Meeting Minutes

Project Name: Wood Residence

Date of Meeting: 6/5/2026

- **Primary Wardrobe** – see attached markups and notes on the shop drawing

SHEET: A / I
DRAWN BY: SJB
PLAN: MAIN LEVEL
PRIMARY WARDROBE
REVISIONS: 1 JUNE 26

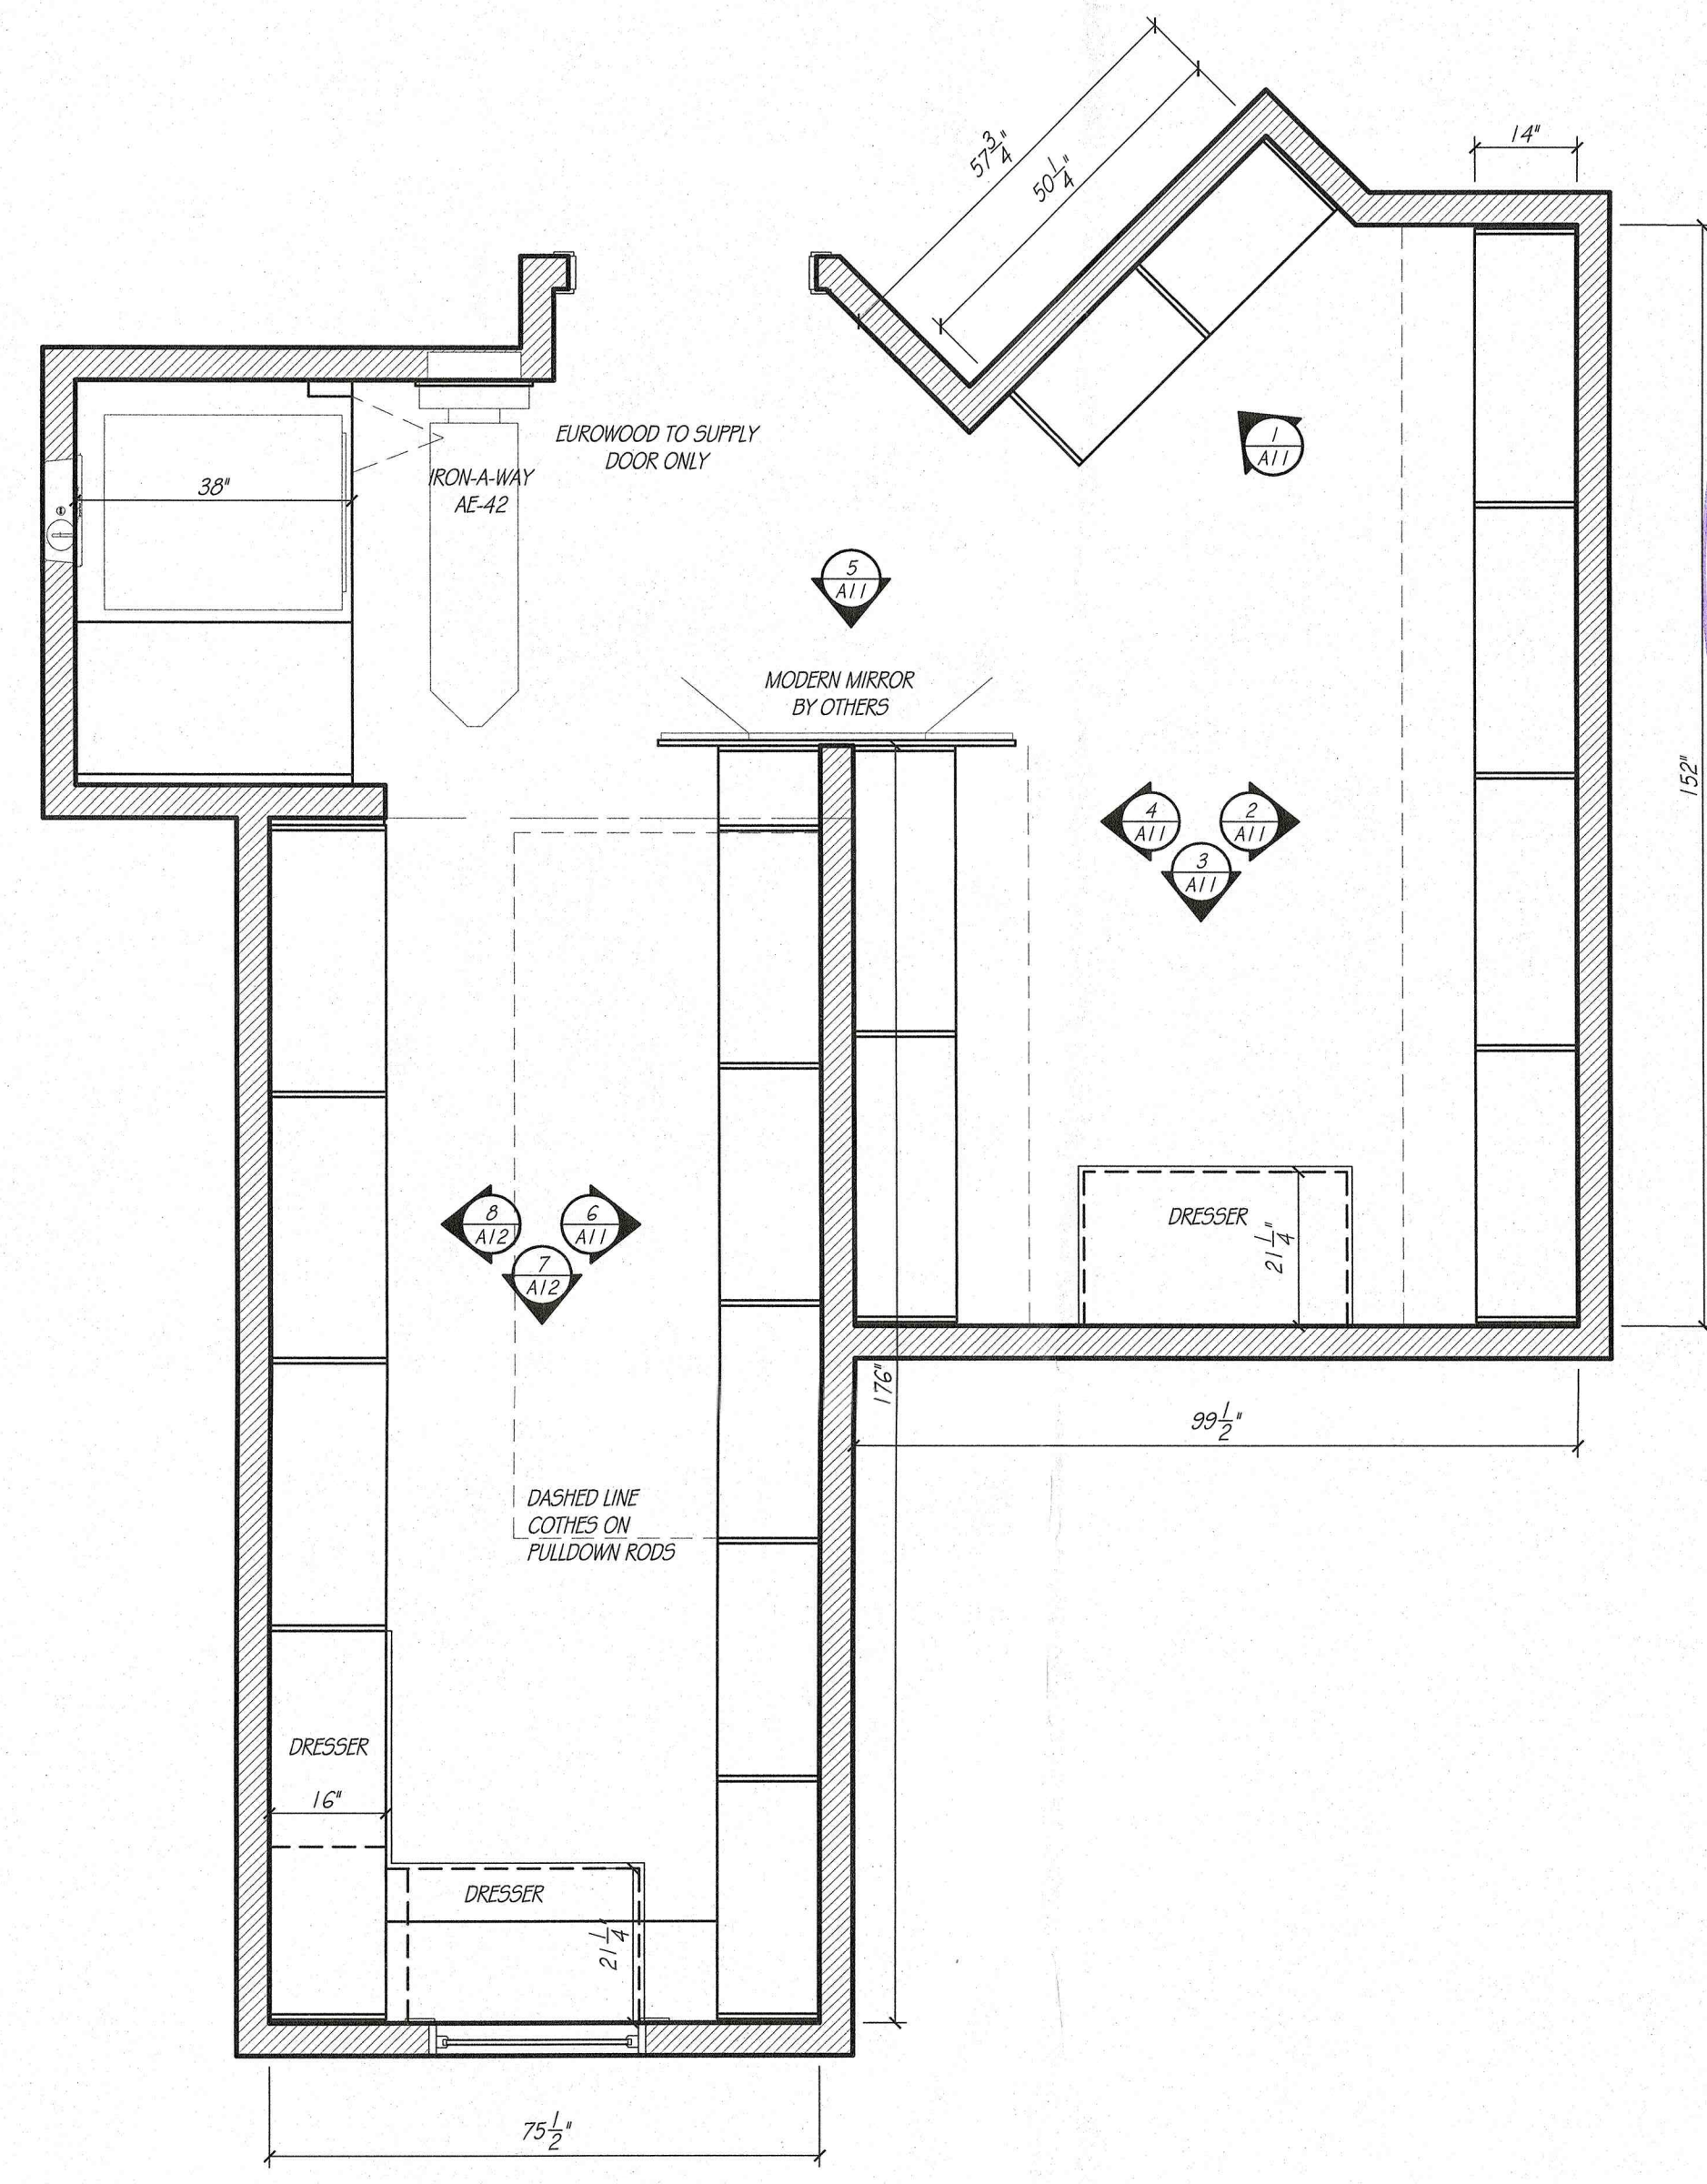
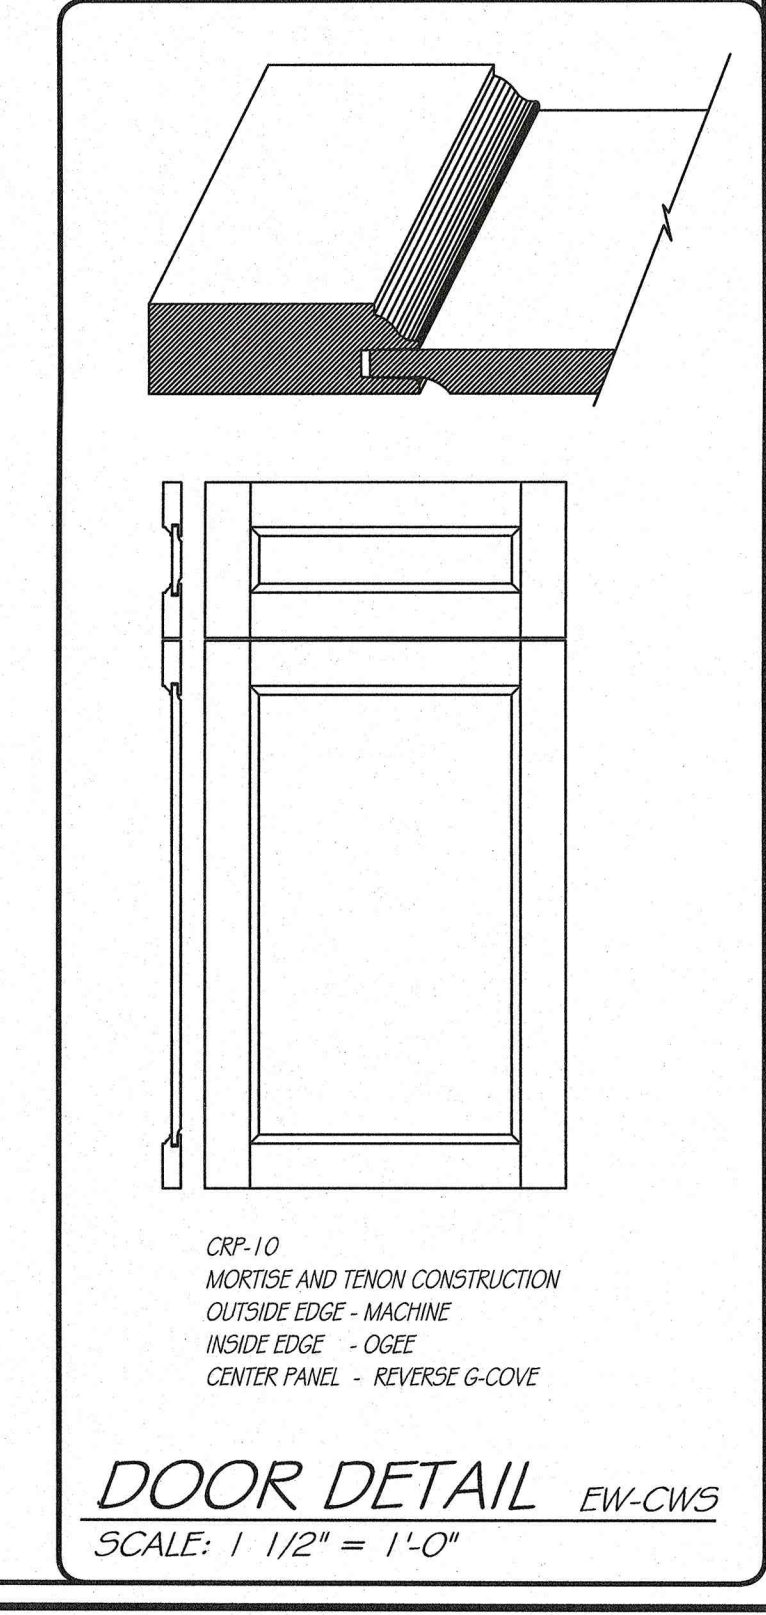
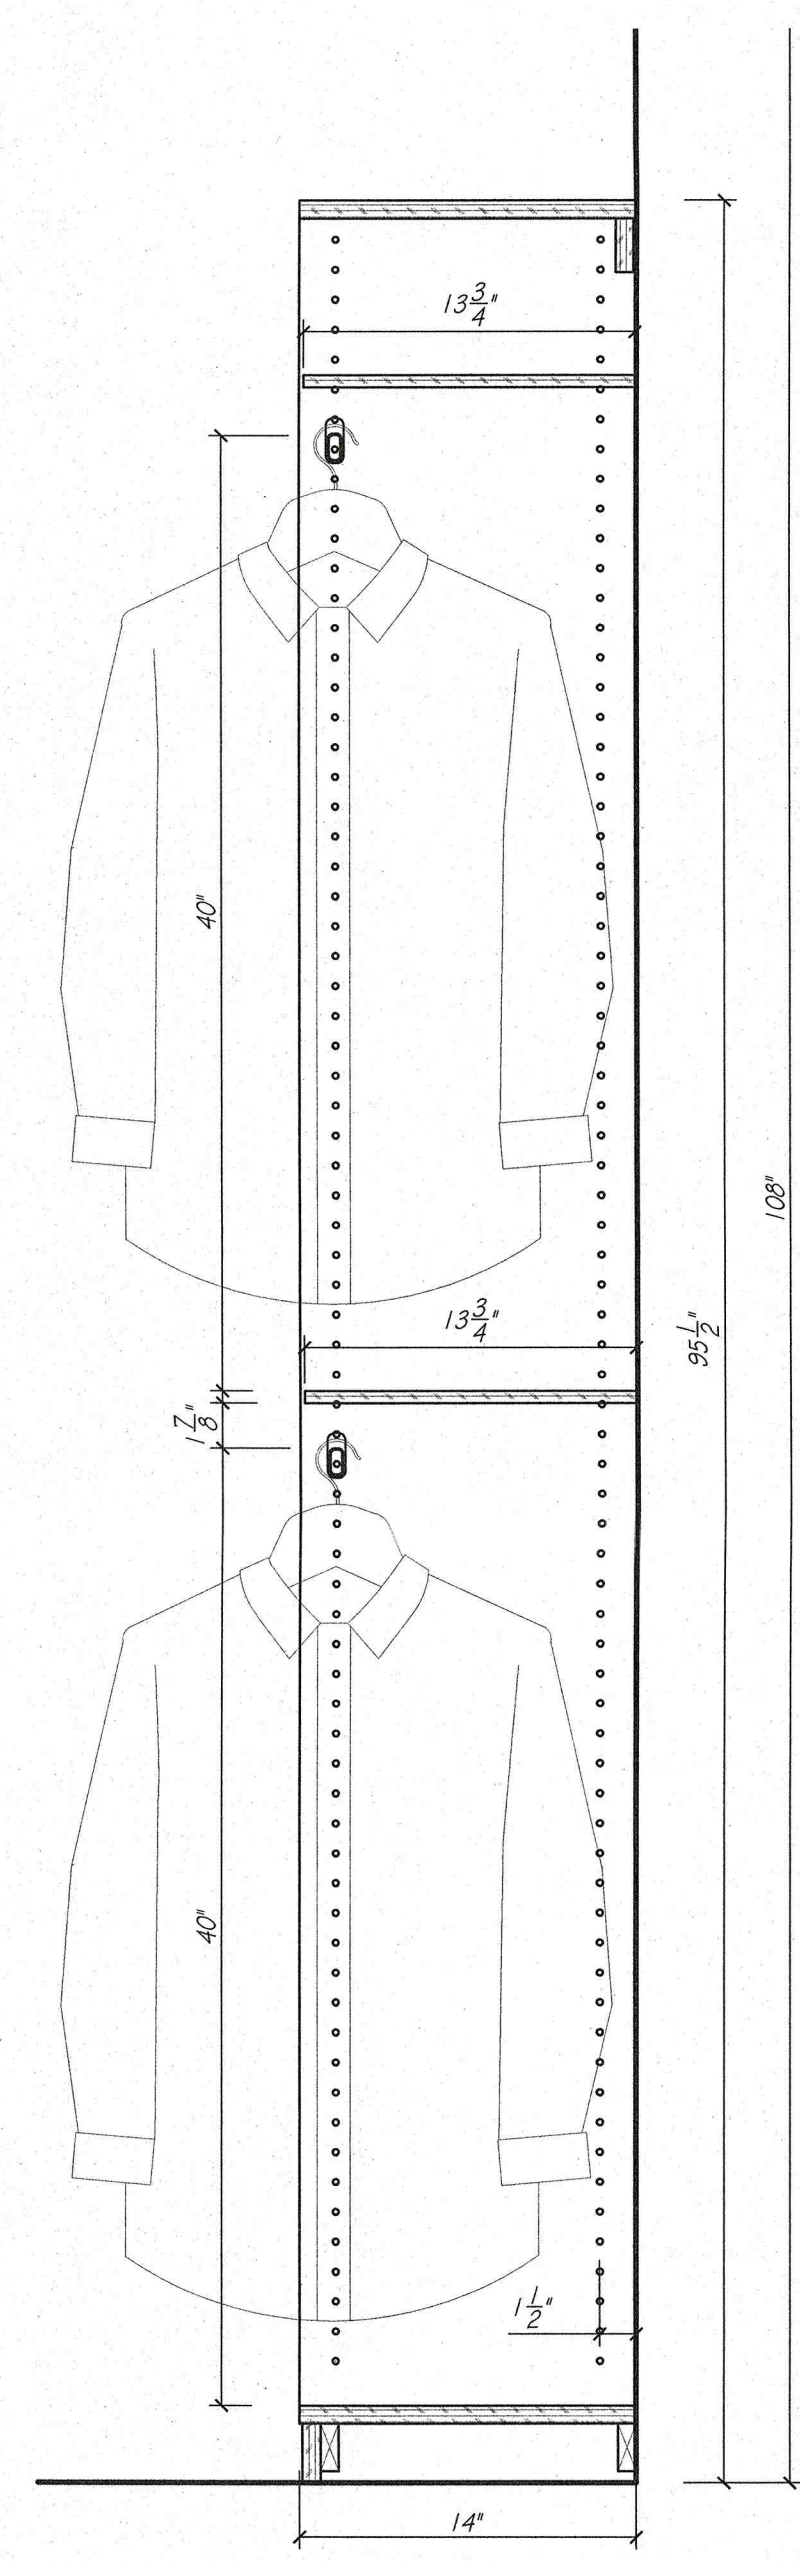
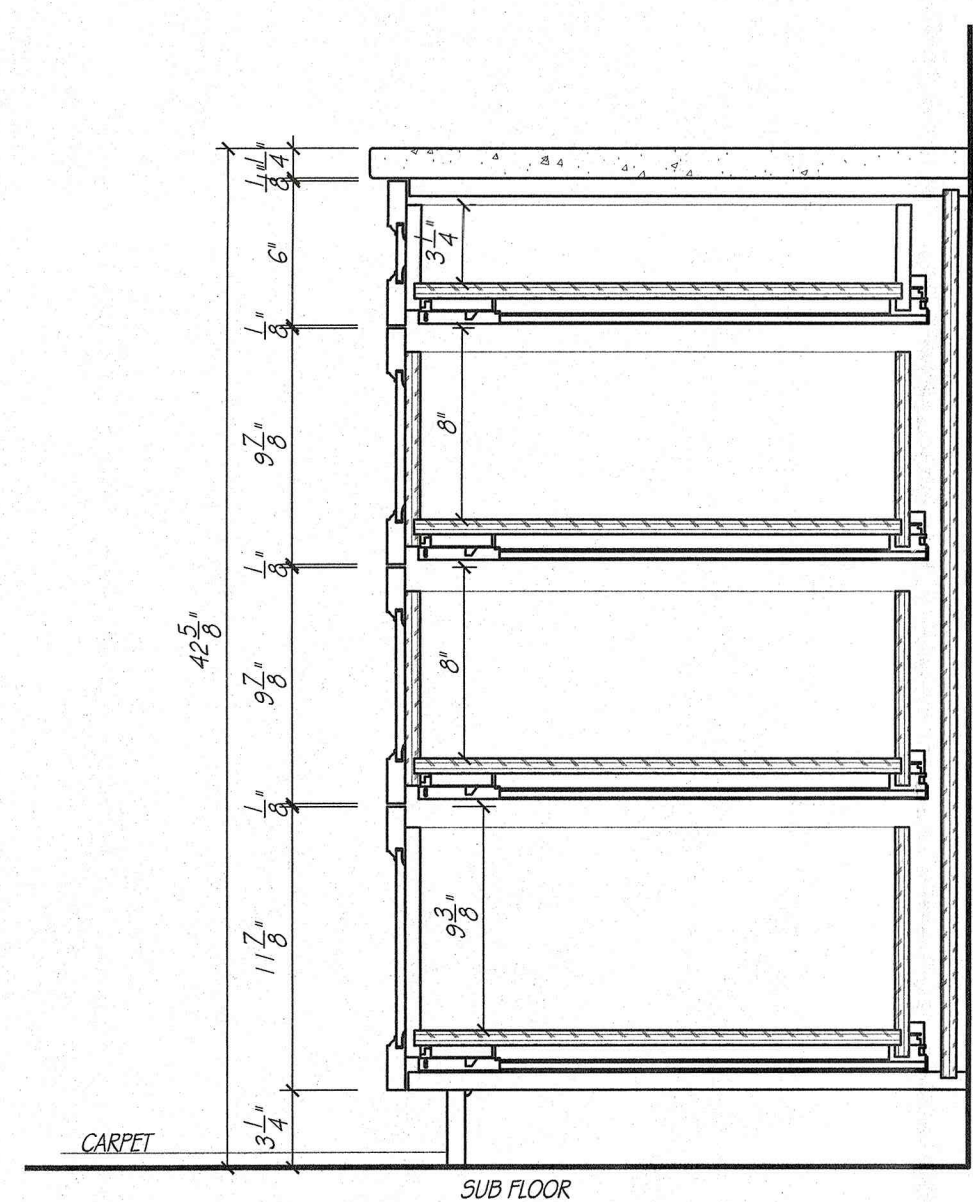
THROTTLED BACKS ON ALL CLOSETS

ADD LIGHTING UP SIDES OF ALL SYSTEM
